DEVELOPMENT PLANS FOR MARRIOTT RESIDENCE

ADDISON, TEXAS

PROJECT RECORD

STORM SEWER OUTFALL MODIFICATION
MARRIOTT RESIDENCE
ADDISON, TEXAS

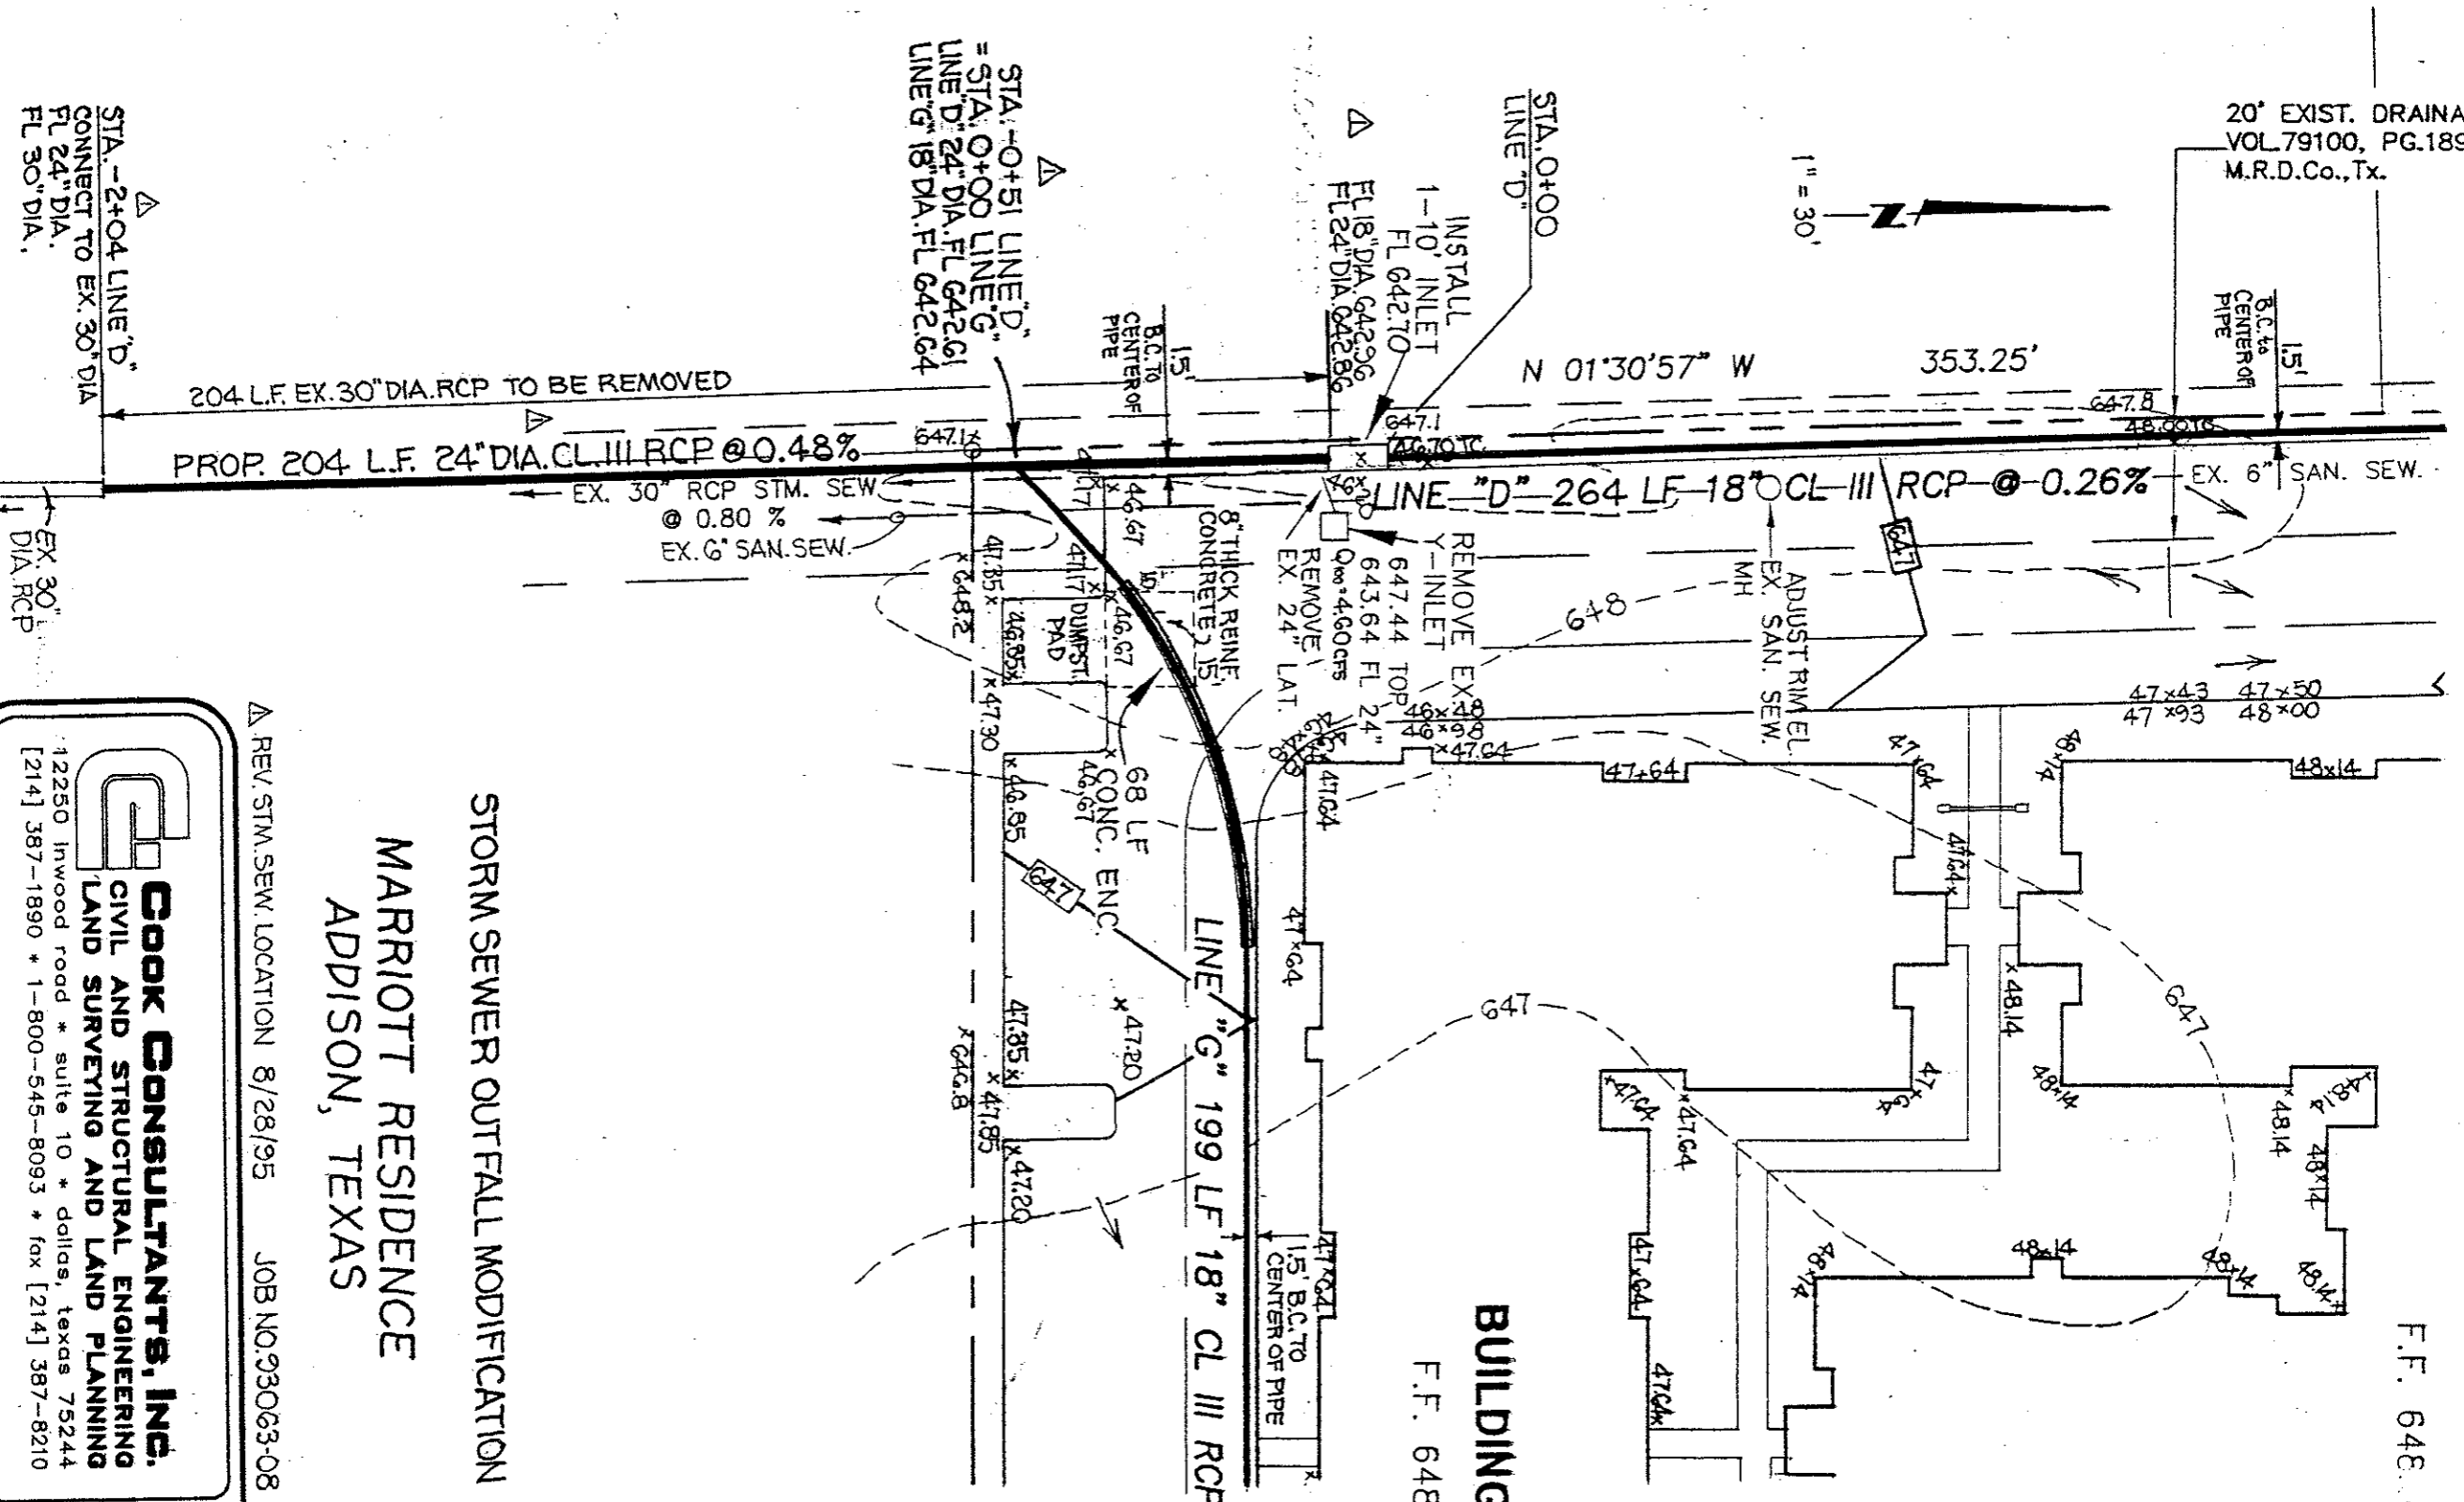
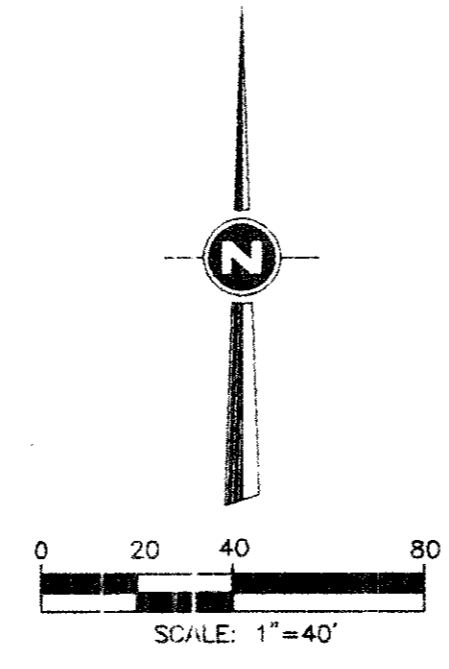
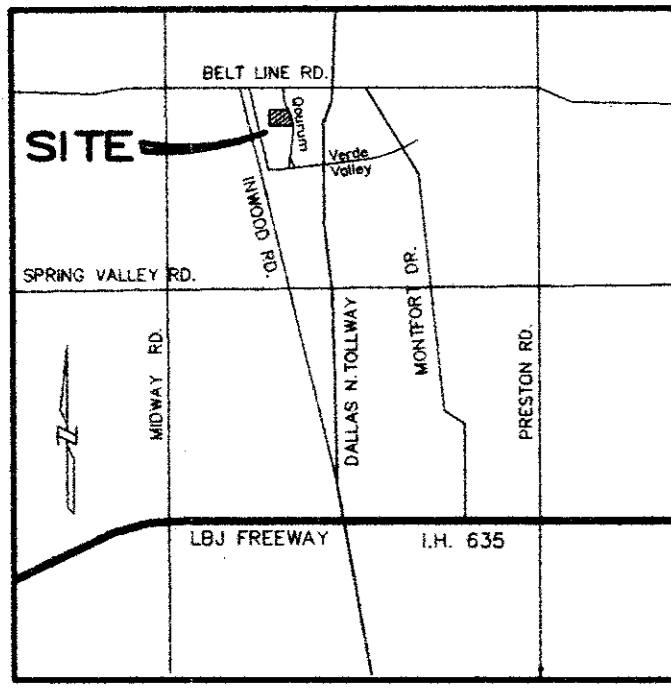
We have found that the existing 30 inch diameter storm sewer pipe at the southwest corner of the project was not installed to the grades per the plans by others. We obtained existing grades at five locations by survey on the 30" diameter pipe at approximately 50 feet intervals. It is apparent that approximately 204 L.F. of the existing 30" diameter pipe needs to be re-installed. The proposed 24 inch diameter RCP has the required capacity of the Marriott project and allows additional capacity to .5 acres minimum on the area of the undeveloped tract to the adjacent southern boundary. There is blue rock existing in this area of the existing 30" diameter pipe As you know, this project is under construction and has been stalled due to resolving this utility problem. Your review and assistance is greatly appreciated.

204 L.F. EX. 30" DIA. RCP TO BE REMOVED
PROP. 204 L.F. 24" DIA. CL. III RCP @ 0.48%

REMOVE EX. Y-INLET
647.44 TOP
643.64 FL 24"
Q_{max} = 4.60 cfs
REMOVE EX. 24" LAT.

REV. STIM. SEW. LOCATION 8/28/95 JOB NO. 93063-08

STATIONING:
STA. -2+04 LINE "D"
CONNECT TO EX. 30" DIA.
FL 24" DIA.
FL 30" DIA.

STATIONING:
STA. -0+51 LINE "D"
= STA. 0+00 LINE "G"
LINE "D" 24" DIA. FL 642.61
LINE "G" 18" DIA. FL 642.64

STATIONING:
STA. 0+00
LINE "D"
INSTALL
1-10" INLET
FL 642.70
